Product Change Notice

New version of Rx-IC and lead frame

AFBR-59F2Z

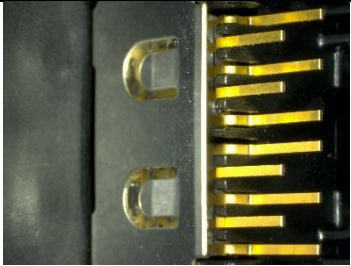
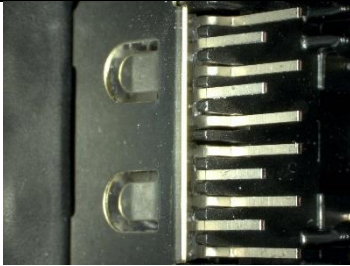
Design improvement for lead frame
 Change lead frame plating from NiAu-spot Ag to NiPdAu
 New version of Rx-IC
 Update of datasheet
 Upgrade of mould compound

Internal lead frame design changed to improve the heat conductance using both GND pins and harmonize assembly process. The thickness of the lead frame remains unchanged.
 Change of lead frame plating to streamline production and increase availability.
